KARNATAKA POWER TRANSMISSION CORPORATION LIMITED

Sub: Draft Central Electricity Regulatory Commission (Indian Electricity Grid Code) Regulations, 2022 -Regarding

**Comments/Suggestions of KPTCL on the Draft Central Electricity Regulatory Commission
(Indian Electricity Grid Code) Regulations, 2022**

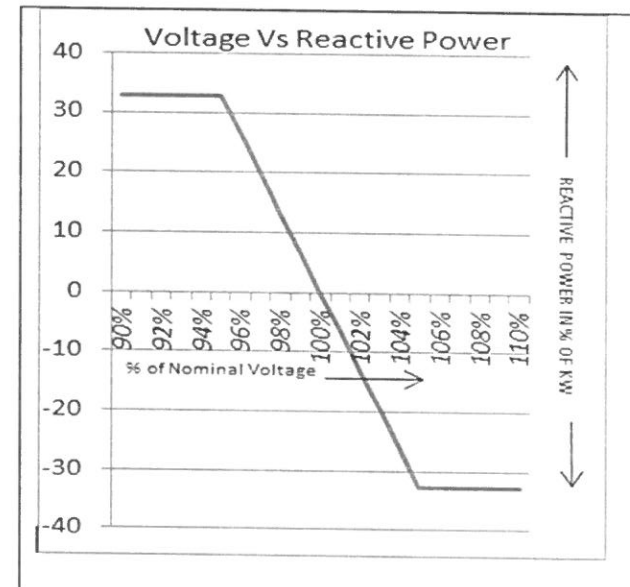
CEA(Technical standards for connectivity to the Grid) Regulations-2007 under section B of Part-II of its notification dated 15.10.2013 stipulates that the generating station using Inverters shall be capable of supplying dynamically varying reactive power support so as to maintain power factor within limits of 0.95 Lagging to 0.95 Leading. The Power factor of 0.95 Lag corresponds to supply of reactive power of 32.9% of KW on real time basis along with supply of active power and 0.95 Lead corresponds to absorption of reactive power of 32.9% of KW on real time basis while supplying active power.

Also, as per the section 8.6.3 of KEGC-2015, the limits for Voltage at the point of interconnection for exchange of VAR is stipulated to be 95% (0.95pu) to 105% (1.05pu) of the real time basis while supplying active power.

Most of the RE Generators are not responding with variations of Grid Voltage by injecting reactive power when the voltage is below the nominal value and absorb reactive power when voltage is above the nominal value.

<p>connectivity regulation in a broad perspective, almost all the RE generators are not following the same and injecting only active power at unity power factor (no reactive power supply/absorption).</p> <p>Hence, it is opined that, the reactive power to be supplied /absorbed against voltage at the interconnection point has to be defined and stipulated in IEGC also. Commercial mechanism for reactive power exchanges from inverter based generation is to be introduced.</p>																								
	(4)	<p>NLDC, RLDCs or SLDCs may direct the users about reactive power set-points, voltage set-points and power factor control to maintain the voltage at interconnection points.</p>	<p>In case of RE sources, Since NLDC, RLDC or SLDC cannot direct individual RE generators with inverters, it is recommended to propose the stipulation for supply/absorption of reactive power is as below:</p>

<table><tr> <th>Voltage in % of rated nominal voltage</th> <th>KVAR to be supplied / absorbed by solar Generator expressed as a % of KW generated.</th> </tr></table>
